Chapter 1

Proposed Action

1.2 PURPOSE OF ADDENDUM

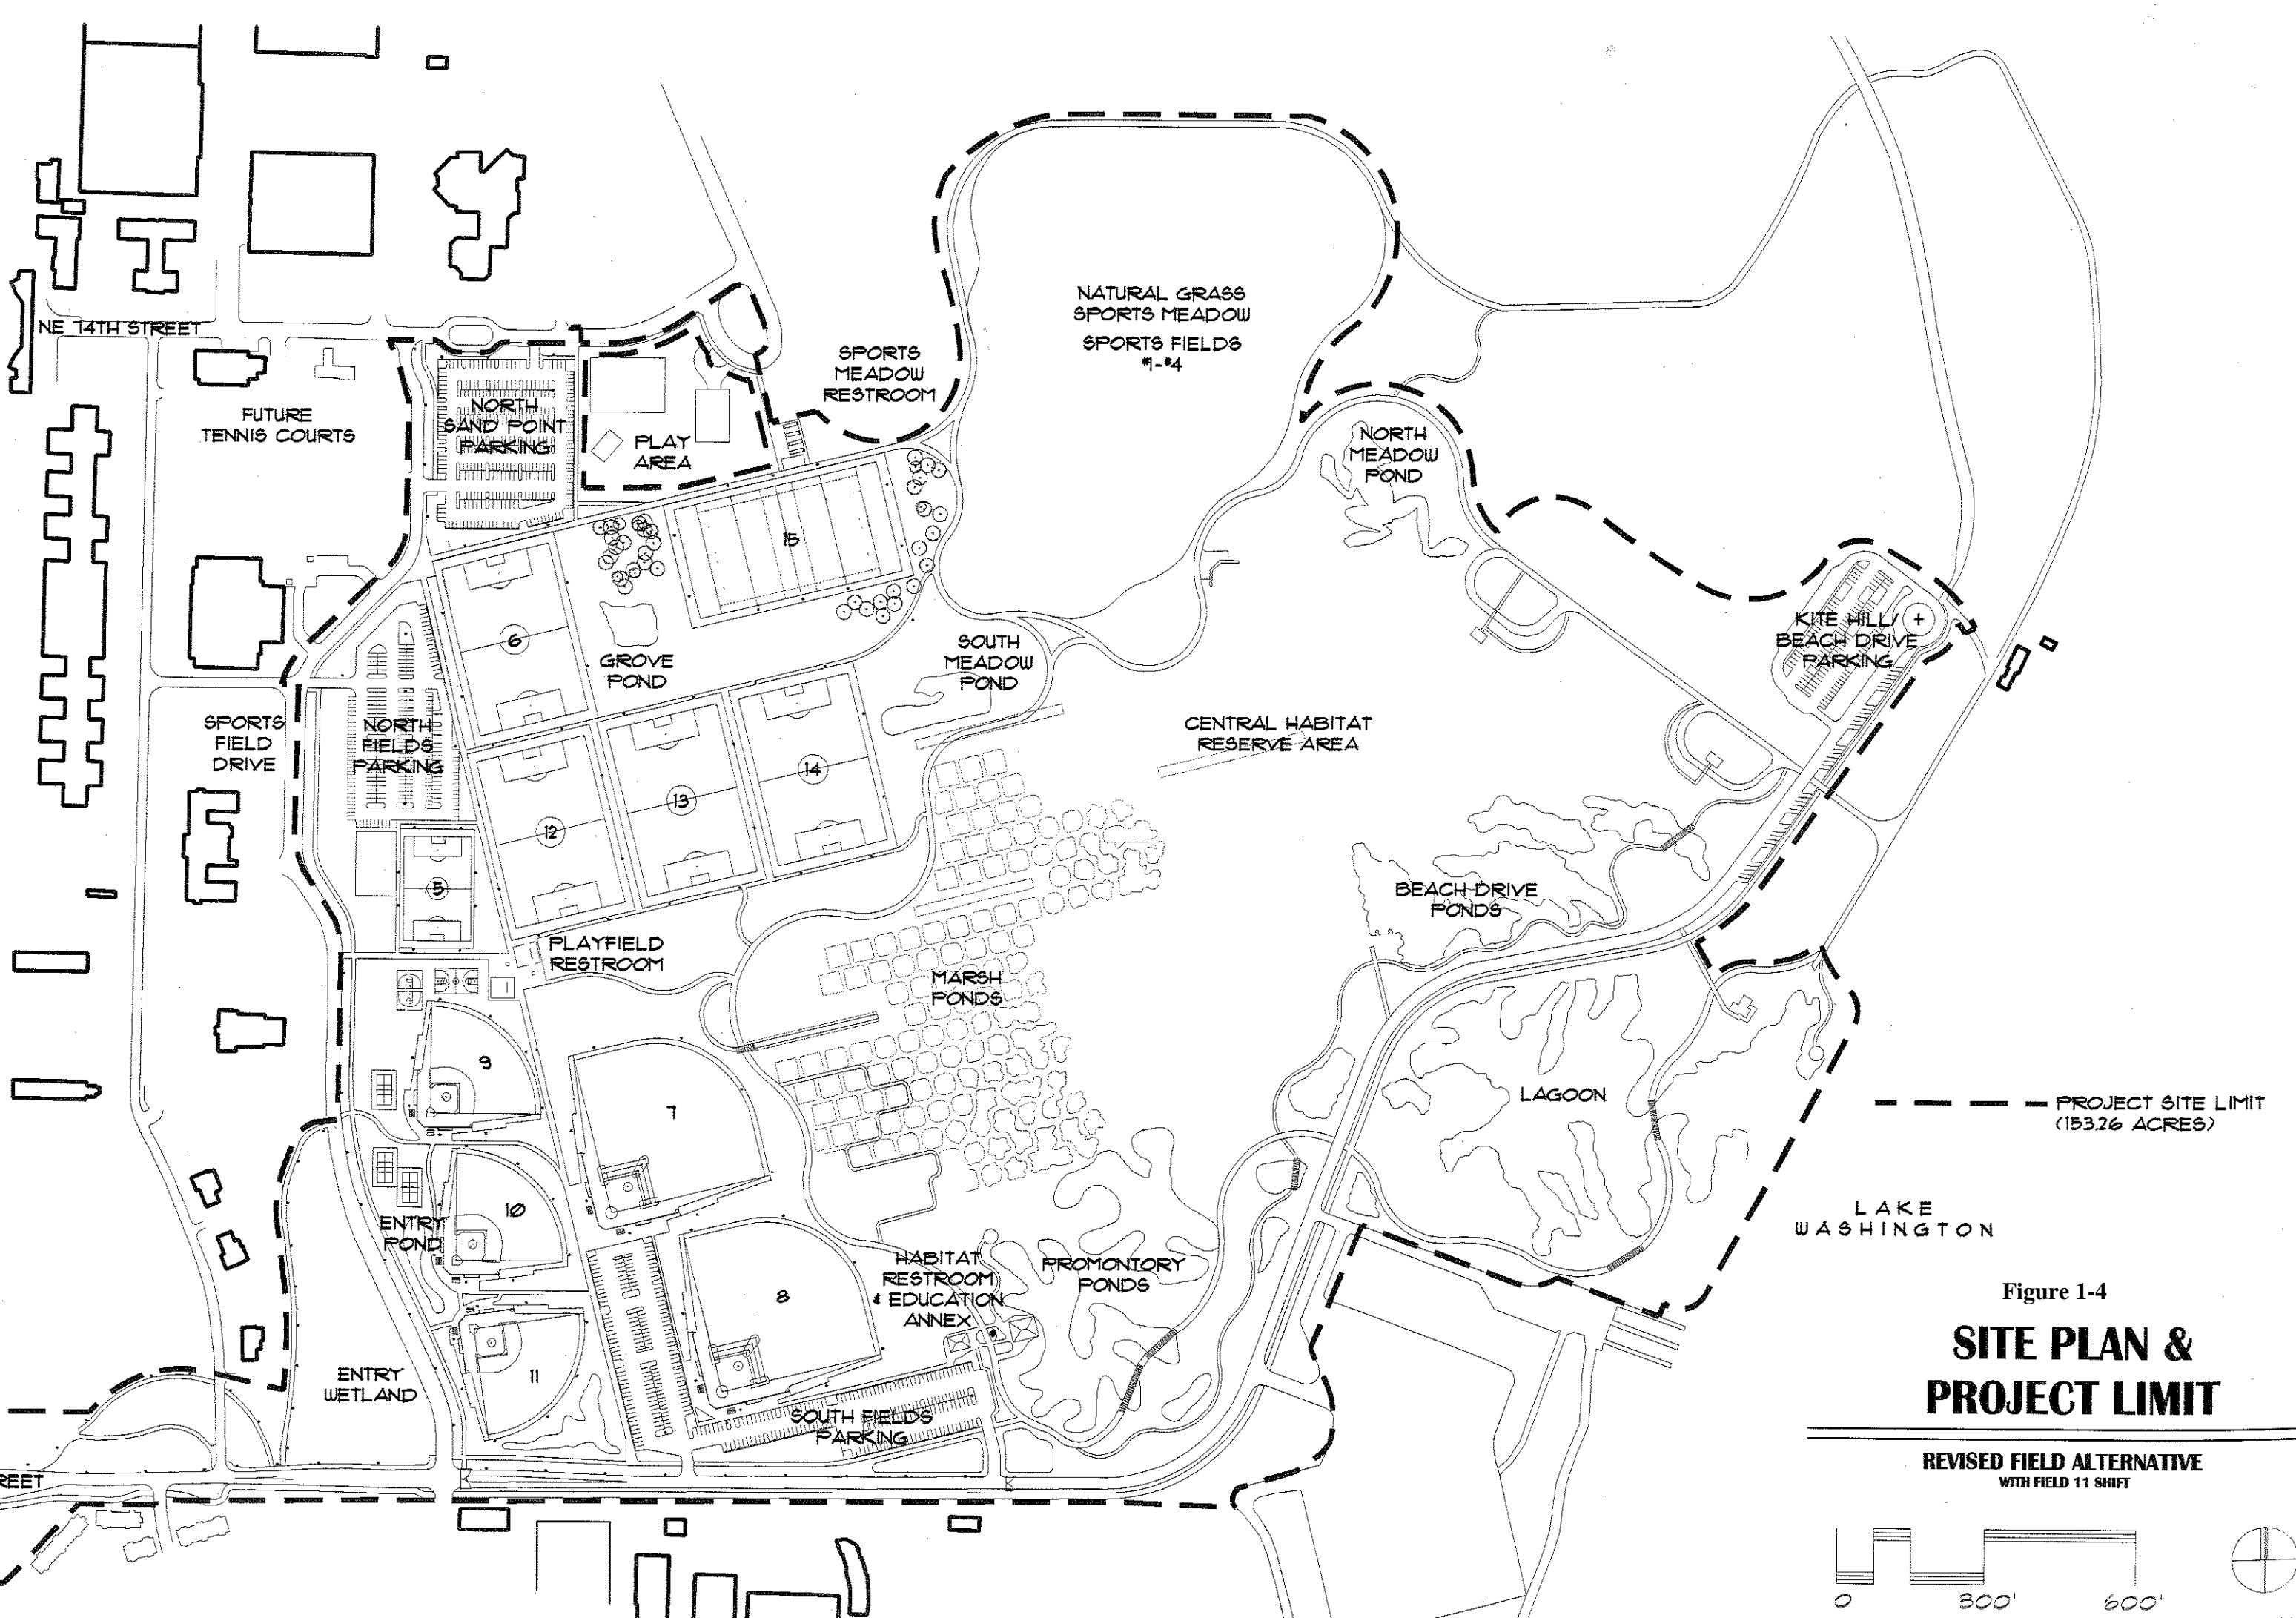
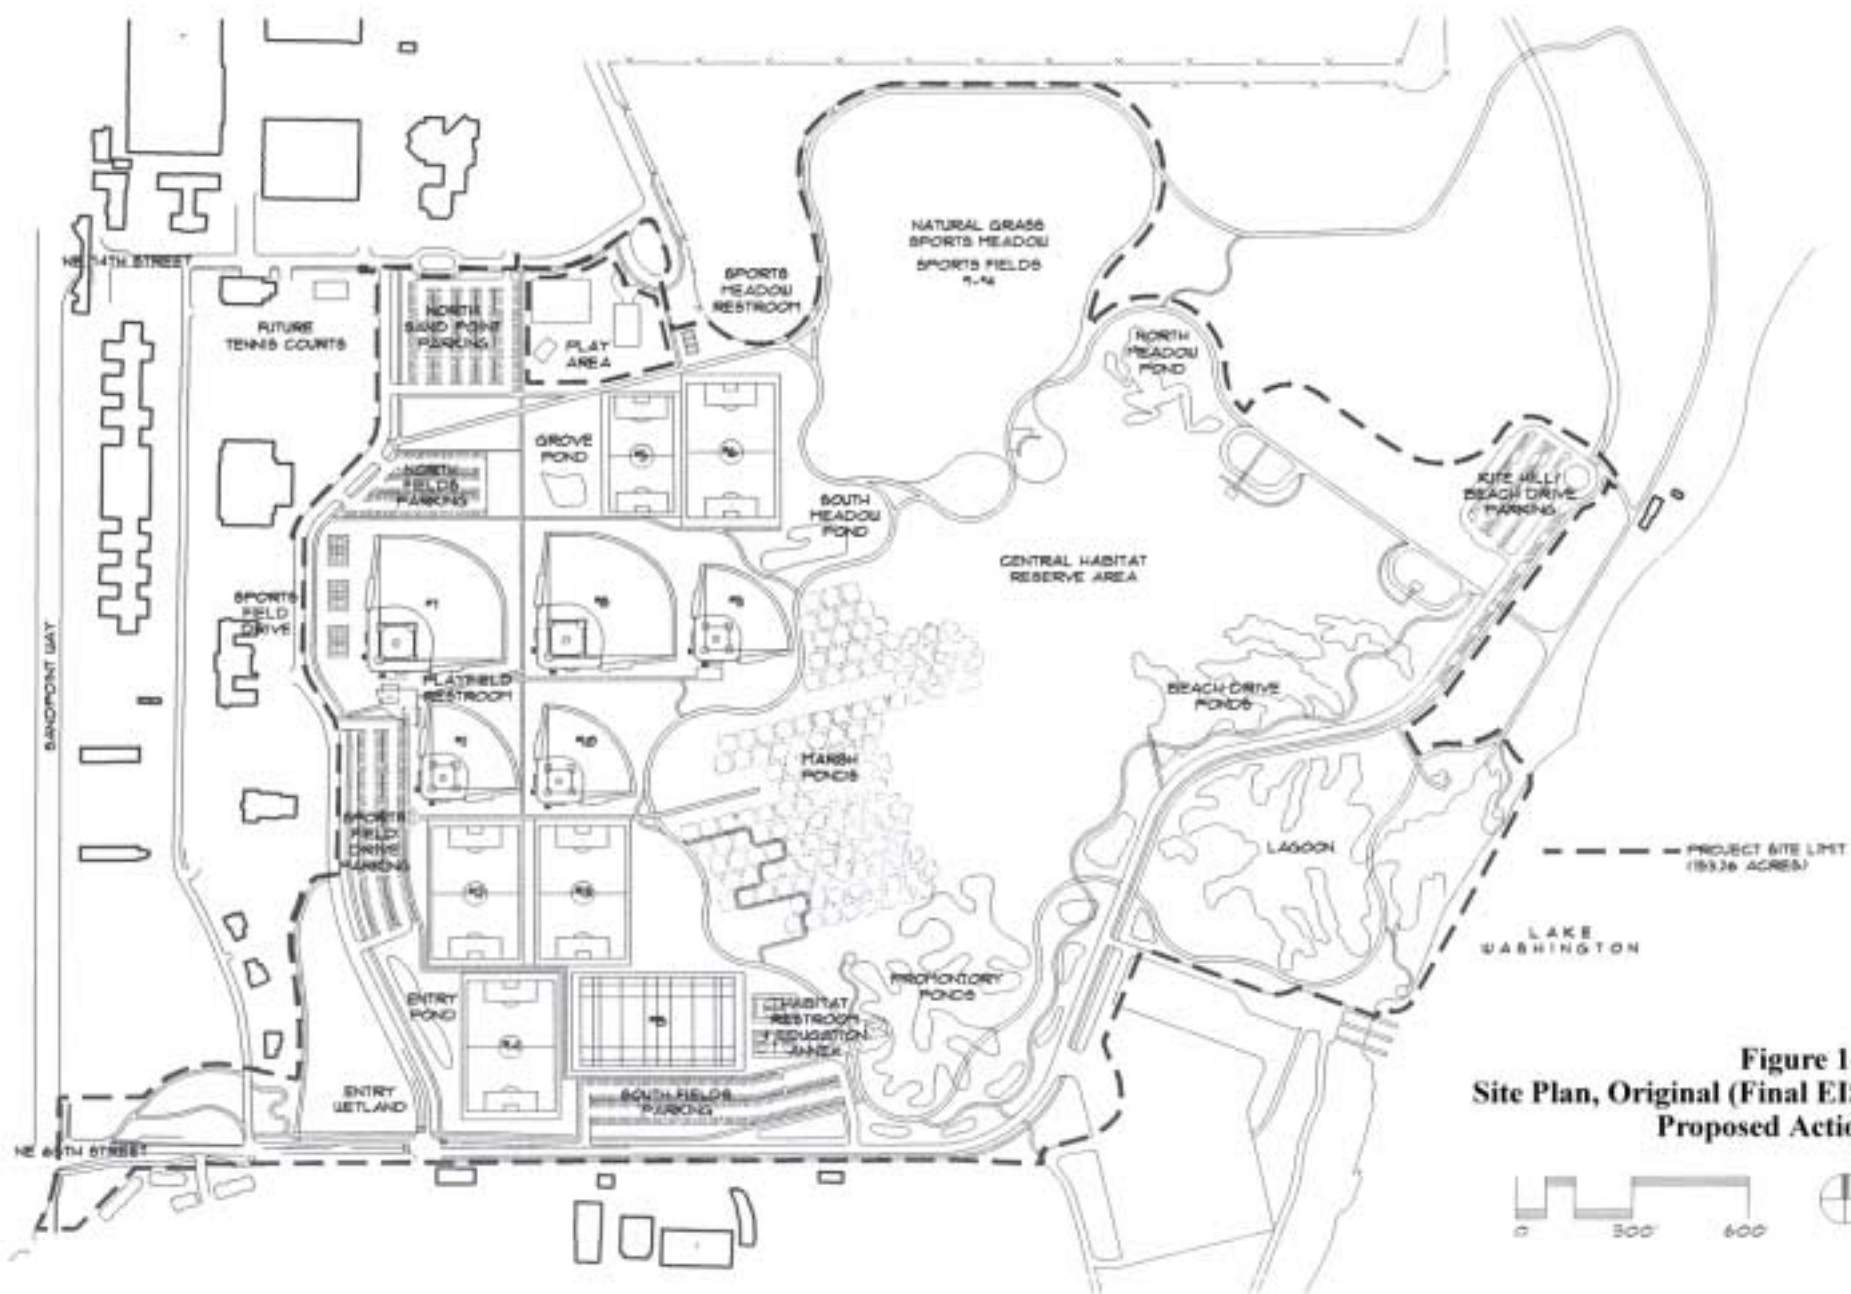
The revised field alternative analyzed in Chapter 2 of this EIS Addendum is graphically represented in **Figure 1-4**. As with the original proposal described in the Final EIS, the revised field alternative includes a sports field complex, a wetland/habitat complex, integrated drainage and a circulation system. To facilitate comparison of the original proposal and the modified plan, **Figure 1-5** is the site plan for the original proposed action that was presented in the Final EIS and the SEIS. Additional graphics addressing specific elements of the proposal are provided in **Appendix A**.

The revised field alternative differs from the original proposed action only with respect to the layout of the sports field complex and the adoption of operational limitations for selected park components. Specifically, the revised field alternative includes:

The proposed action still includes 11 synthetic-turf lighted fields along the western side of the project site. The “footprint” of this field area and the general location of the field complex remain consistent with the original proposed action described in the Final EIS. However, the revised field alternative repositions the layout of the 11 fields, generally clustering like field types (by programmed use) together. Specifically:

- Field 15 (rugby) has been shifted from the southeast corner of the sports field complex to the north, adjacent to the sports meadow;
- Field 6 (soccer) has been shifted to the west and Fields 12, 13 and 14 (soccer) have been shifted from the southwest part of the site to the north, to form a soccer complex of 4 fields.

- Field 5 (mod soccer) has been shifted to the south and west, where it is adjacent to the 4 full-size soccer fields, basketball courts, restroom/concession structures, and North Fields parking lot. Field 5 also has somewhat smaller dimensions in the revised plan, but would still be large enough for youth soccer.

- Fields 9, 10 and 11 (little league baseball/fast pitch softball) have been shifted from the central part of the field complex to the southwestern corner along Sports Field Drive, forming a baseball complex of 5 fields. The southwestern-most field has been rotated to move the backstop/home plate (and primary noise source) to the north, away from residential units located south of 65th Street.

- Fields 7 and 8 (adult baseball/slow-pitch softball) have been shifted from the west-central part of the field complex to the southeastern corner, adjacent to the wetland/habitat complex and east of the little league/fast-pitch fields.

One full-size basketball court, two half-size basketball courts, three sand volleyball courts and the inline-hockey facility are also relocated in the revised field alternative to the westernmost edge of the sports complex, between the synthetic-turf fields and Sports Field Drive. The court facilities occupy the location of the Sports Field Drive parking lot included in the original proposal; in conjunction with landscaping and related amenities, this change would provide a more “community park-like” character to the area and would help to buffer the on-site housing from activity at the sports fields. Park lawn and planting areas for the revised field alternative are indicated in **Sketch A3** in **Appendix A**.
